Staff Report – Planning & Zoning Item

Date: November 20, 2017
Case No.: Z-17-16
Request: PD MF (apartments) to PD MF (townhomes)
Applicant: Dana Tatum

Z-17-16 Hold a public hearing and consider a zoning change from Planned Development Multiple Family for apartments to Planned Development Multiple Family for townhomes on a 6.285 acre tract of land, located on the northwest side of East Loop 121, just southwest of Holland Road.

DEVELOPMENT CONCEPT PLAN

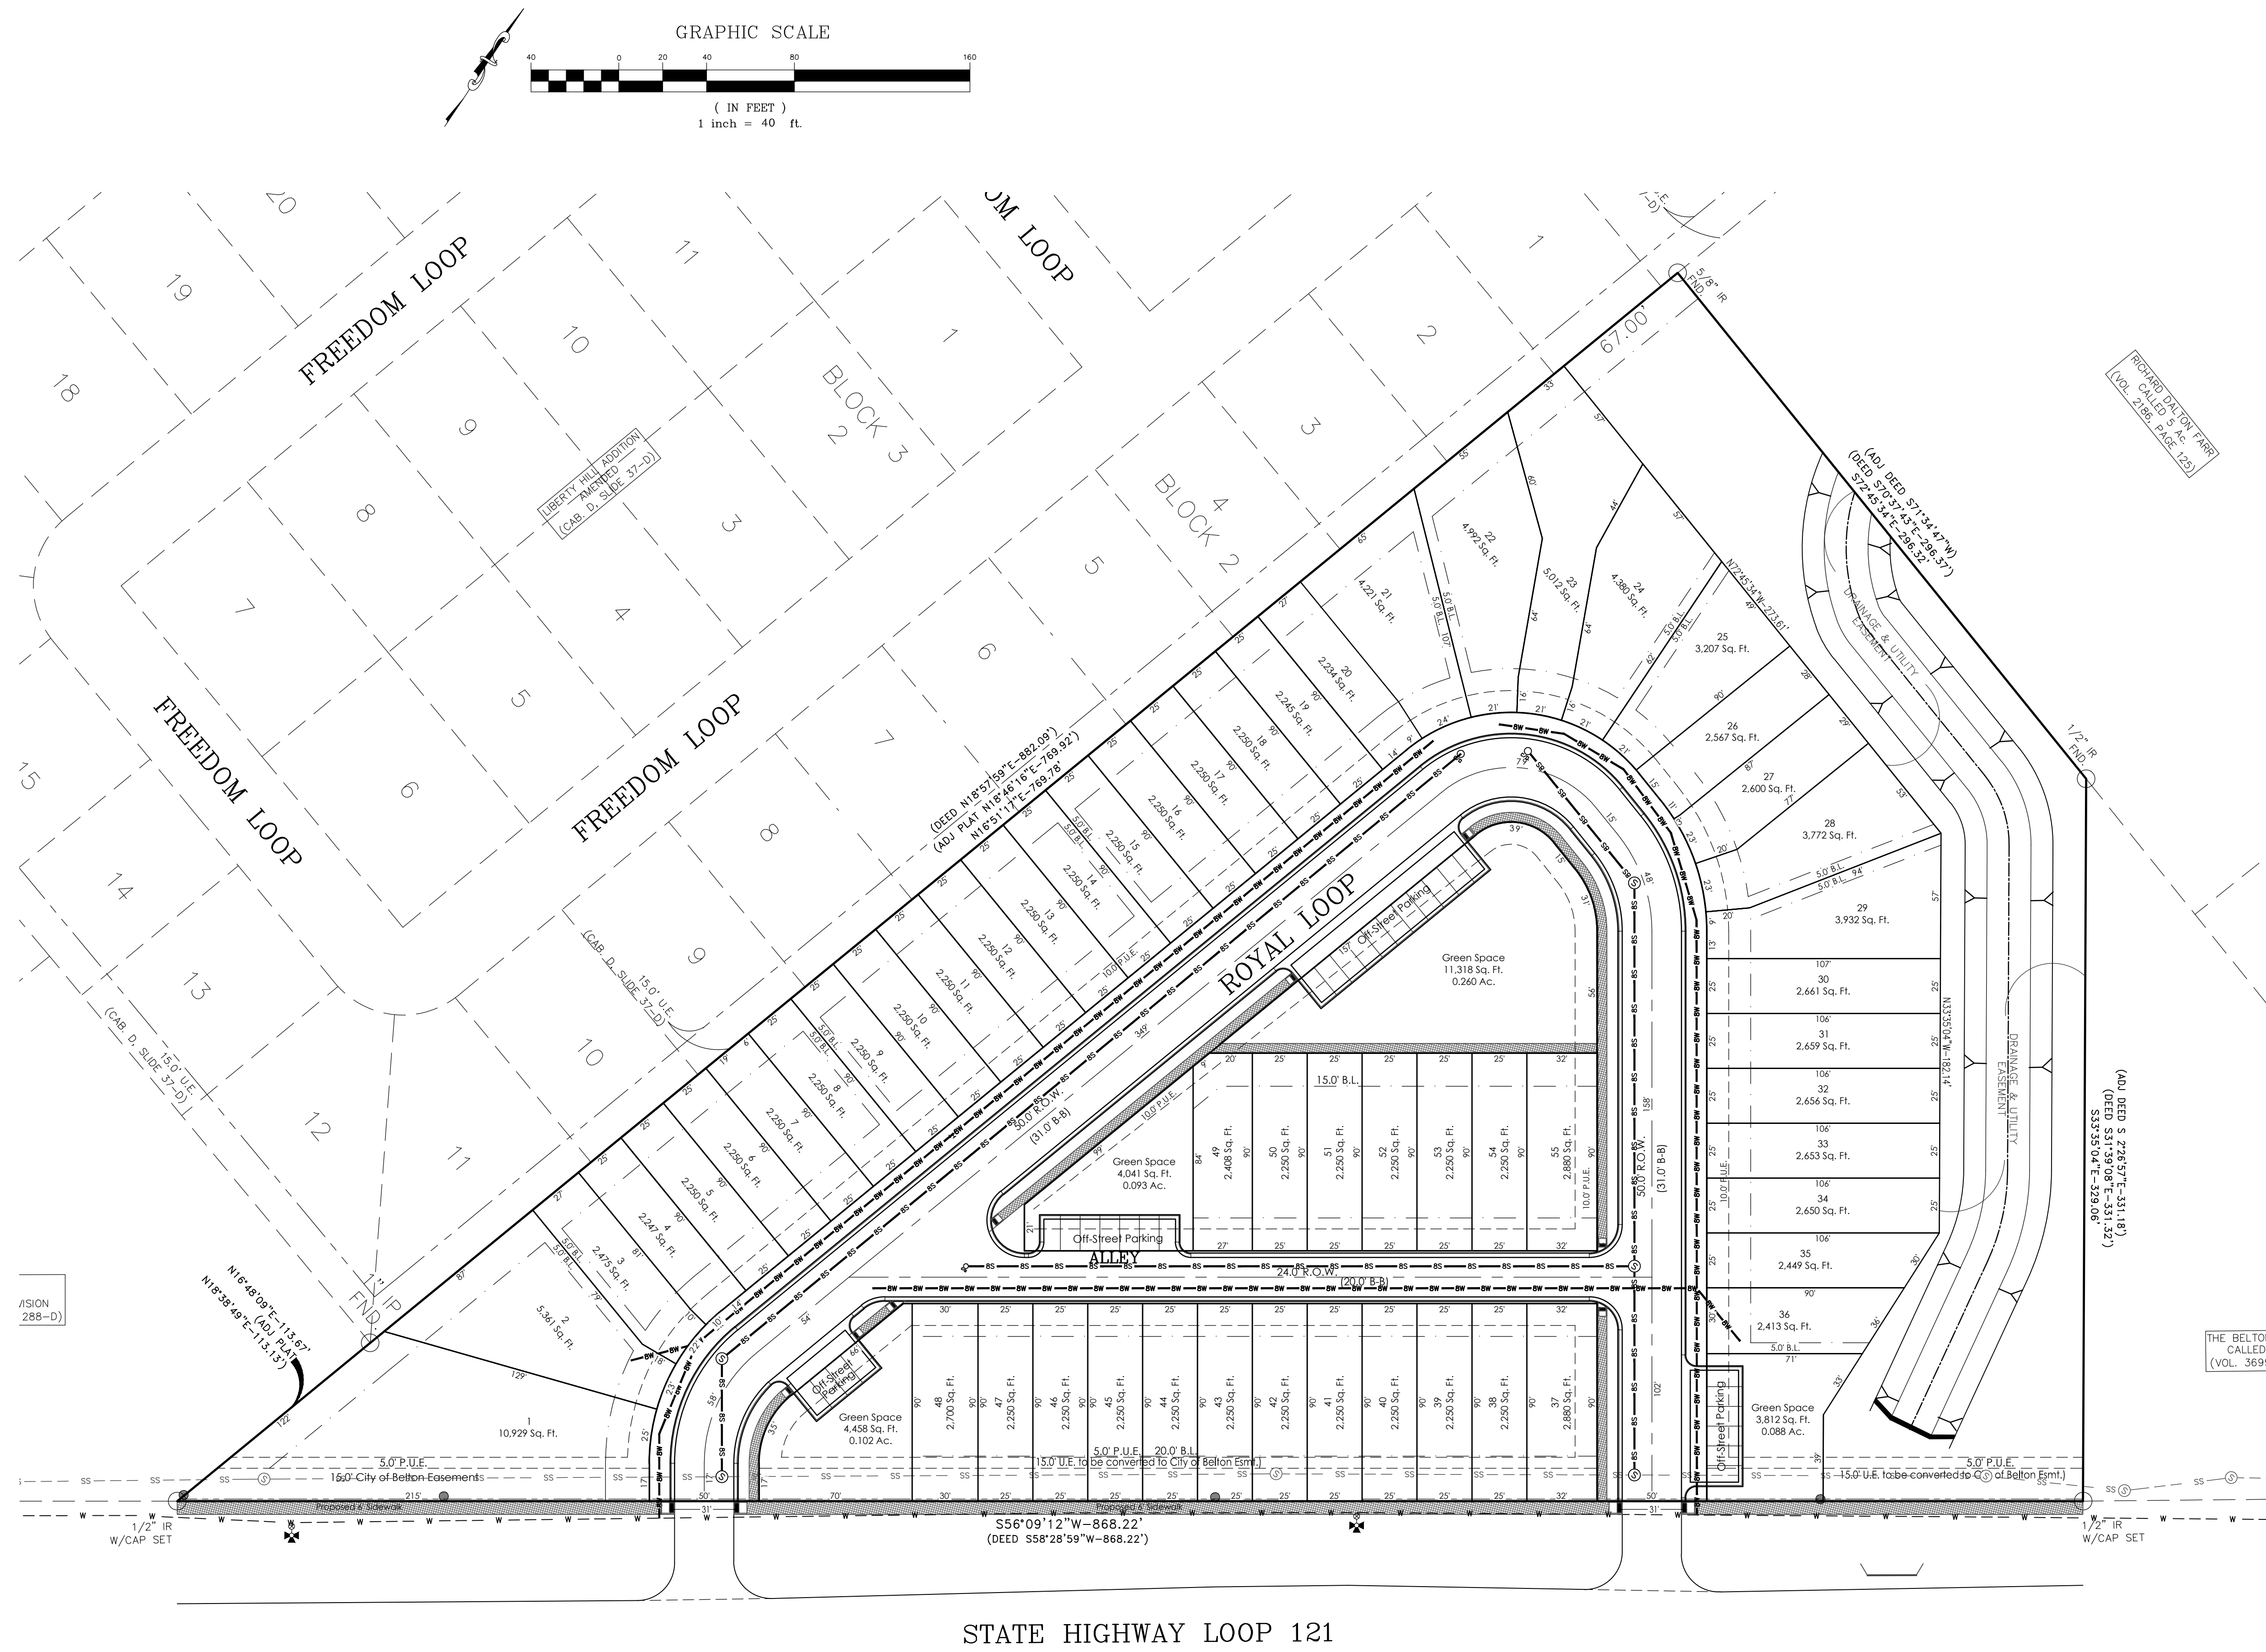
The applicant is proposing to construct a townhome community with 9 cluster modules containing a total of 55 dwelling units. The cluster modules range from 2 units to 12 dwelling units; however, the cluster modules do not exceed 300 feet in length. The Planned Development proposal would allow for a maximum of 12 dwelling units in a cluster module. The lot sizes in this development vary, with the minimum lot size at 25 feet in width and 90 in depth, a total of 2,250 square feet in area. The proposed lots comply with the lot width and depth requirements; however, some lots are smaller than the required lot area of 2,700 square feet. The applicant is requesting the Planned Development proposal allow for some of the lots to be 2,250 square feet in area. Since the applicant is proposing a zoning change to allow for townhomes instead of the previous request for apartments, the overall density is much less than previously approved, an estimate of 113 dwelling units; therefore, these requests appear to be reasonable. All of the dwelling units will consist of 90% masonry, in accordance with the Design Standards.

The applicant is proposing to construct two means of ingress/egress from Loop 121. According to Section 34, Off-Street Parking and Loading Requirements, of the Zoning Ordinance, two off-street parking spaces are required for each unit. The applicant has stated that both garages and a driveway will be provided for each residence. In addition to the parking requirements, the applicant is proposing to construct 4 parking areas within 200 feet of each residence with a total of 28 parking spaces. The parking areas will be owned and maintained by the Homeowner's Association. The applicant is also proposing to provide 0.543 acres of green space/parkland for this townhome community that will be owned and maintained by the Homeowner's Association. Fencing along Loop 121 is required to be constructed of wood with a capped topped rail and masonry columns spaced every 50 linear feet.

Recommend approval of zone change from Planned Development Multiple Family for apartments to Planned Development Multiple Family for townhomes, with development regulated under the Design Standards for Type Area 11 standards as follows:

1. The allowable uses of the property shall conform to the Multiple Family Zoning District in all respects, except for the following:
 - a. Townhomes are a permitted use;

- b. Minimum front yard setback of 20 feet, instead of the required 25 feet;
 - c. Minimum side yard setback of 10 feet between buildings with openings, instead of the required 15 feet;

- d. Minimum rear yard setback of 20 feet when the building is in excess of one story and adjacent to a Single Family Zoning District, instead of the required 60 feet;

- e. Minimum lot area of 2,250 square feet, instead of the required 2,700 square feet; and
 - f. Maximum of 12 dwelling units in cluster module not exceeding 300 linear feet, instead of the required 3 dwelling units.
